PLAN CORRECTIONS REPORT PrelimPlat-000382-2026 FOR MARION COUNTY, FL

PLAN ADDRESS: 92Nd SE Loop Bellevue, FL 34420	PARCEL: 37896-000-00	
APPLICATION DATE: 02/18/2026	SQUARE FEET: 0.00	DESCRIPTION: Sandy Clay Residential
EXPIRATION DATE: 02/18/2028	VALUATION: \$0.00

PRELIMINARY PLAT
SANDY CLAY RESIDENTIAL
MARION COUNTY, FLORIDA

SHT. **04.09**

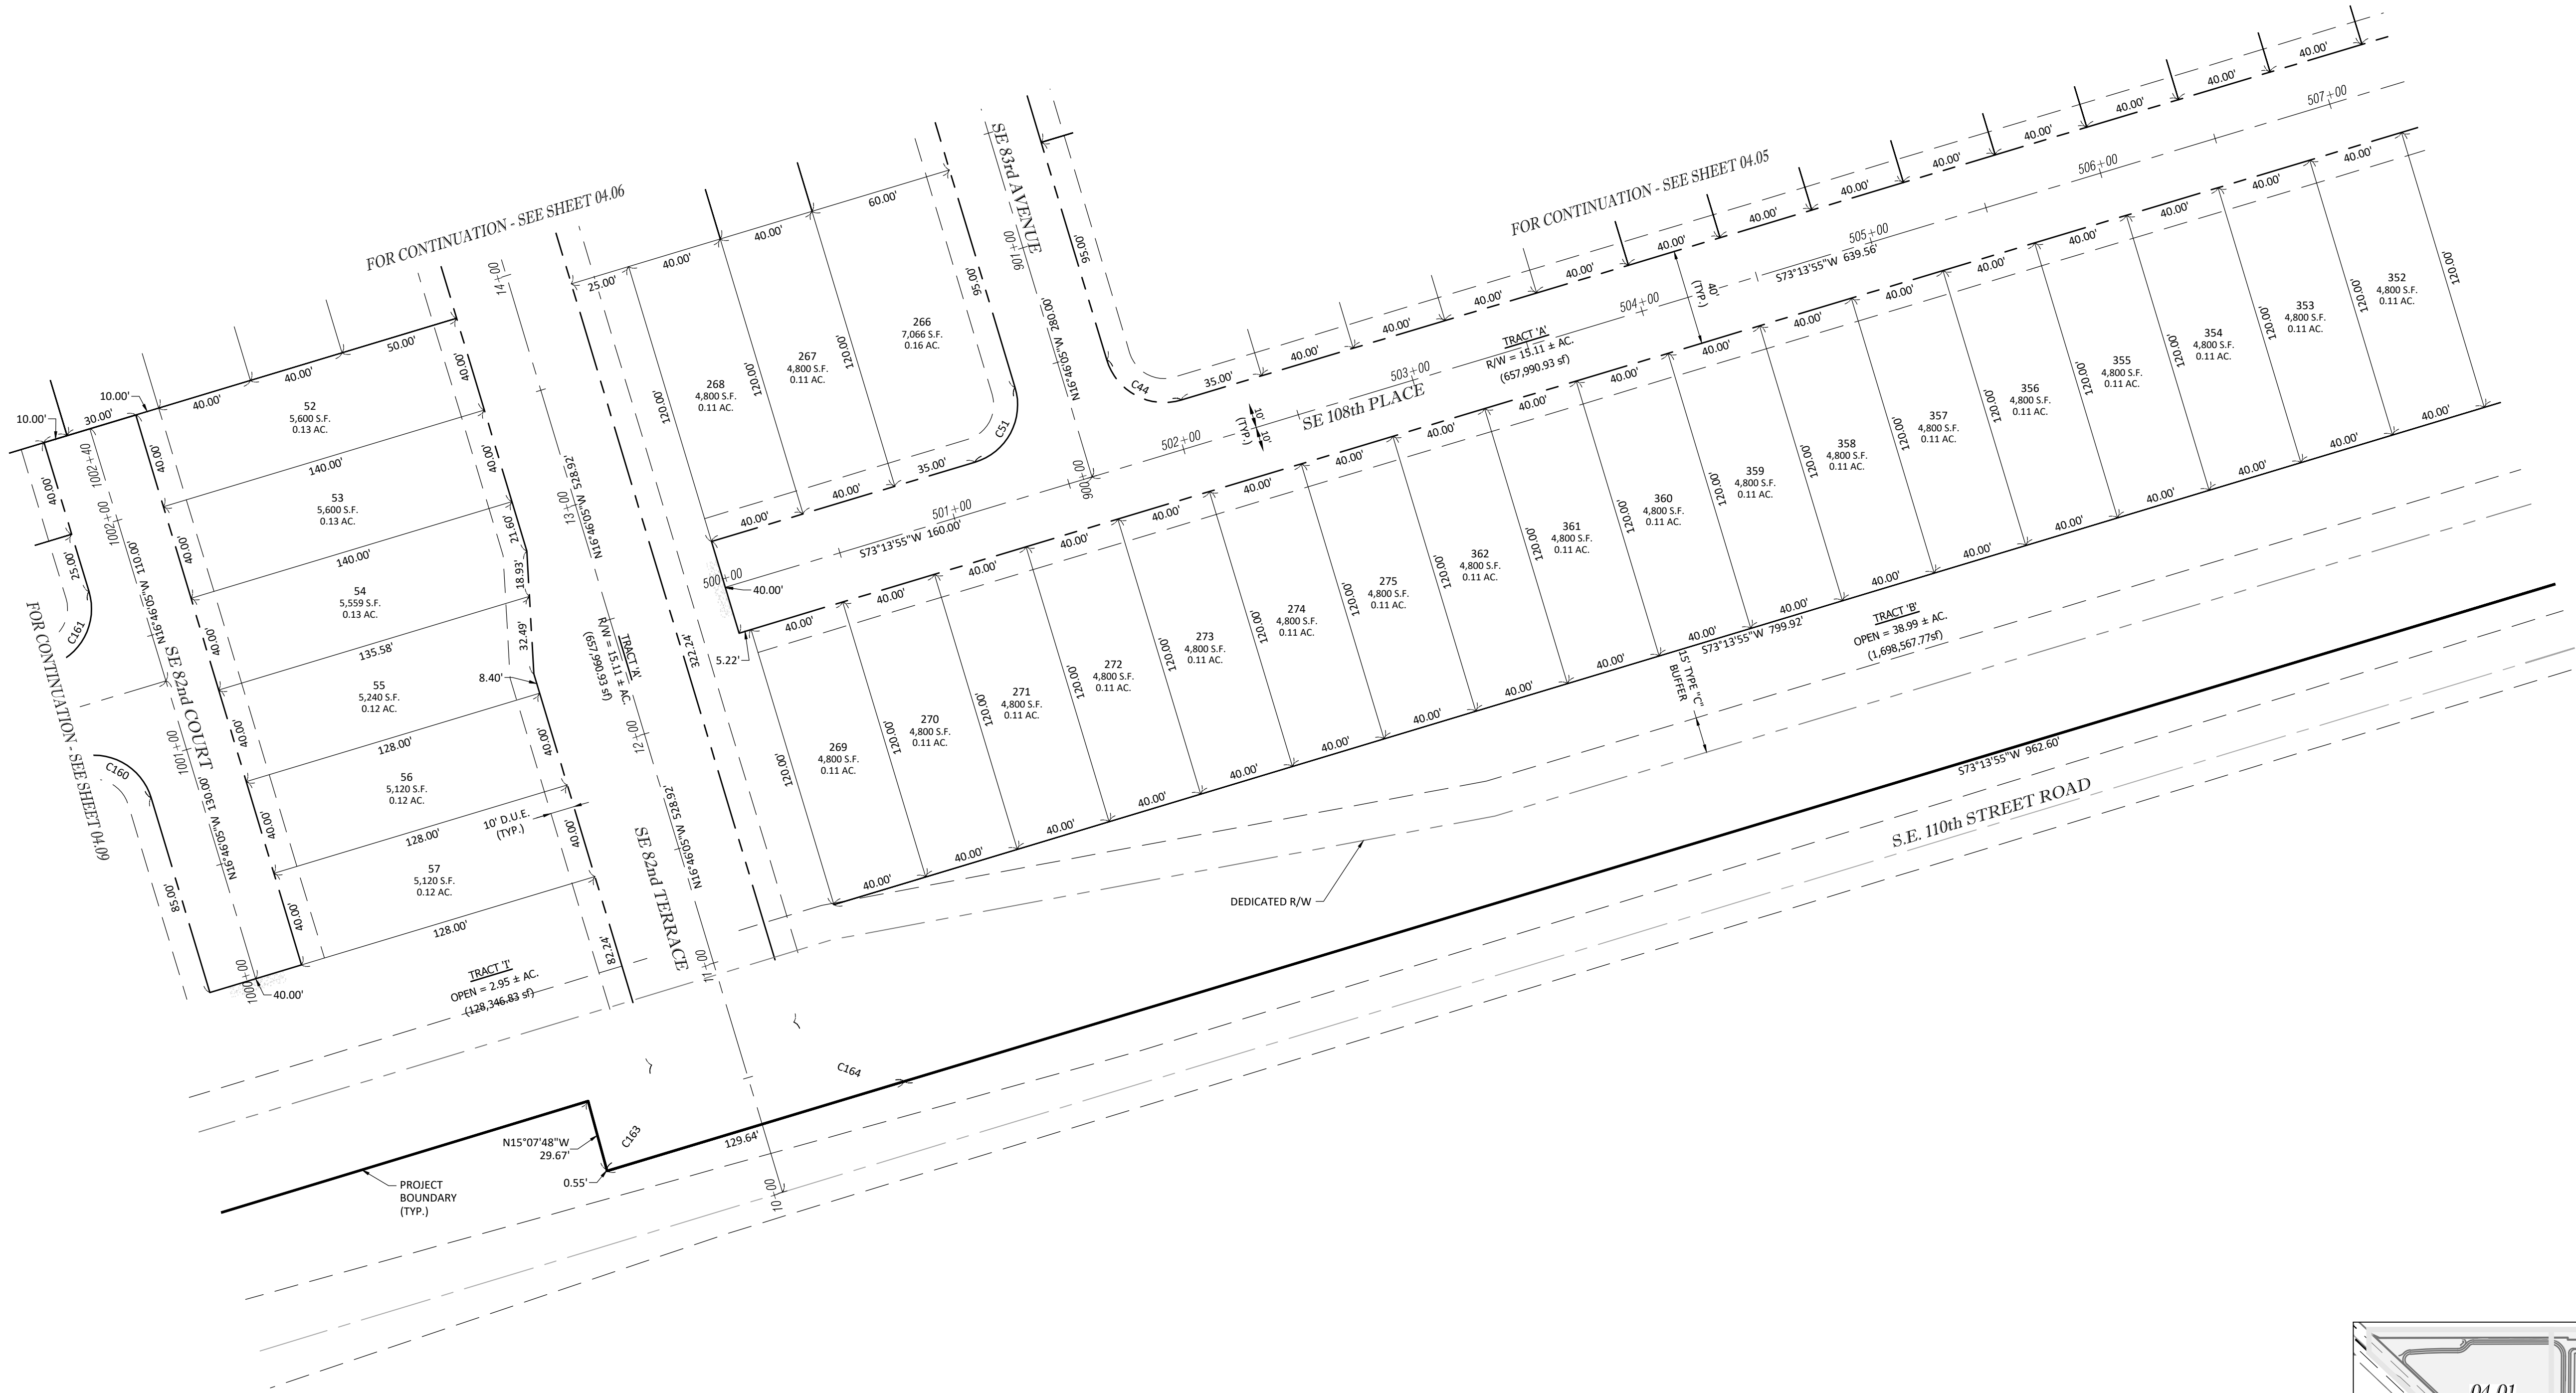
Corrective Action: On Sheet 04.09, Lot 35 is incorrectly labeled as Lot 2155.

Corrective Action: On Sheet 04.09, Lot 35 is incorrectly labeled as Lot 2155.
